SECTION 905 -- PROPOSAL (CONTINUED)

Number	Description
1	Revised Wage Rates; Revised or Added Plan Sheet Nos. 8001-8002; Amendment EBSx Download Required.
2	Revised Table of Contents; Revised NTB No. 5569; Deleted SP 907-417-1; Added SP 907-828-1; Revised Bid Items; Revised or Added Plan Sheet Nos. 8001 & 8002; Amendment EBSx Download Required.

Bridge Rehabilitation on US 80 over the Pearl River (Bridge No. 46.4), known as Federal Aid Project No. BR-7314-00(032) / 1075693020 & 3021 in Hinds & Rankin Counties.

**BRIDGE AT STA. 481+45.00
 US80 ACROSS PEARL RIVER LAYOUT,
 GENERAL NOTES & ESTIMATED QUANTITIES**
 DIR OF STRUCTURES, STATE BRIDGE ENGINEER - SCOTT WESTERLIND, P.E.
 DIR OF STRUCTURES, ASST. STATE BRIDGE ENGINEER - MICAH DEM, P.E.

WK. NO.
1 OF 12
 SHEET NO.
8002

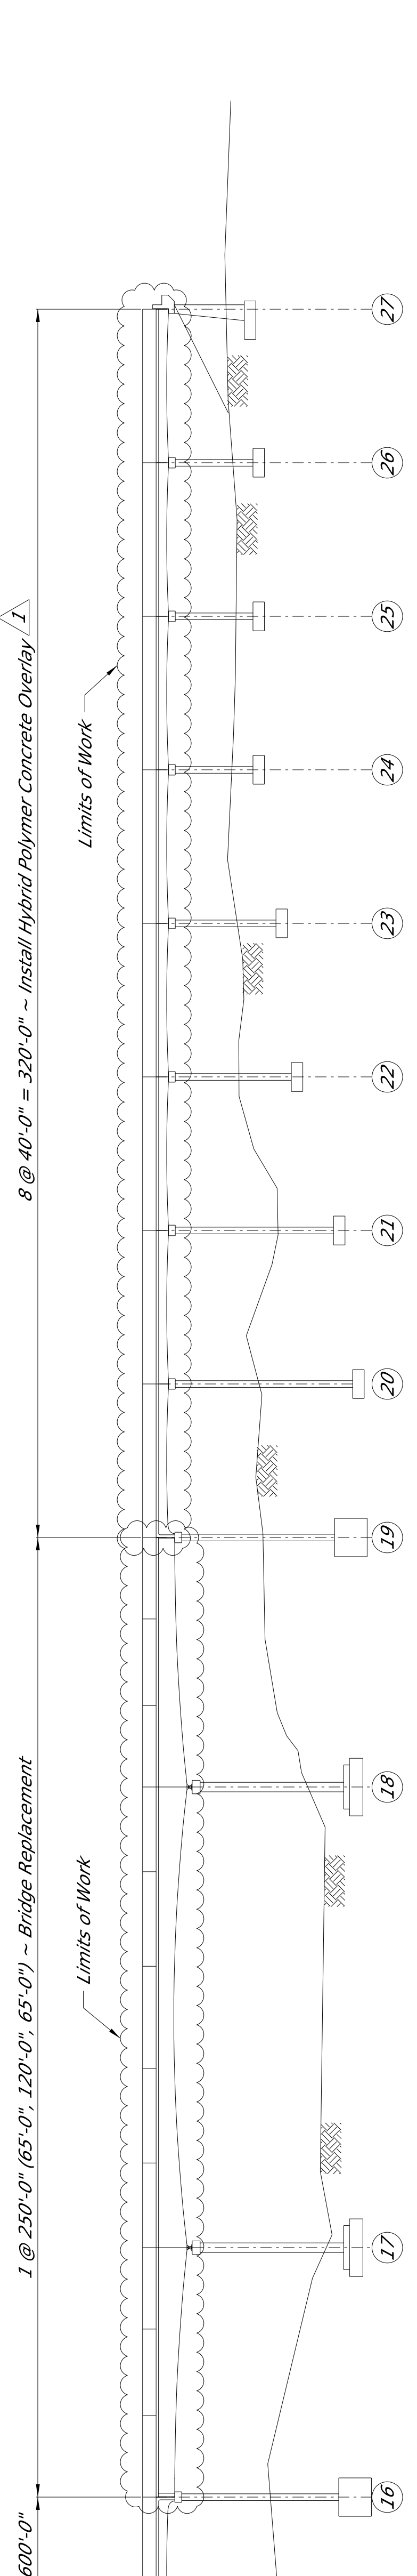
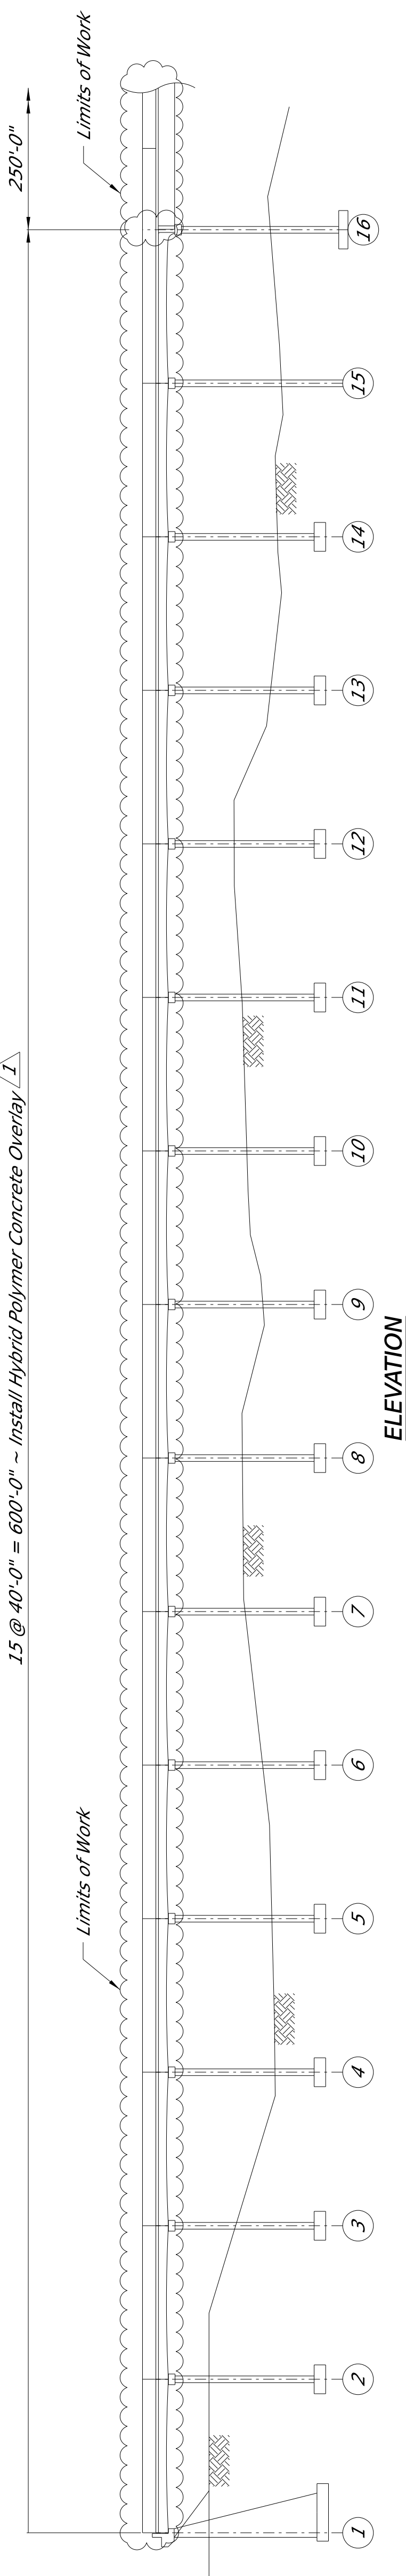
DATE	REVISION	BY
1/19/24	Revised quantities	AWH
1/4/24	Revised Pay Item and Notes	JAF

- Hybrid Polymer Concrete Overlay shall be placed in accordance with Special Provision Subsection 907-828.03 and with the approved materials outlined in Special Provision Subsection 907-828.02.
- The overlay shall be placed at a minimum thickness of 1/2" and a maximum thickness of 1".
- All materials and labor associated with this item of work shall be paid for by the cubic yard of overlay under the Pay Item No. 907-828-4001, Hybrid Polymer Concrete Overlay.
- Hybrid Polymer Concrete Overlay shall be applied to the bridge deck between gutter lines on the spans indicated.
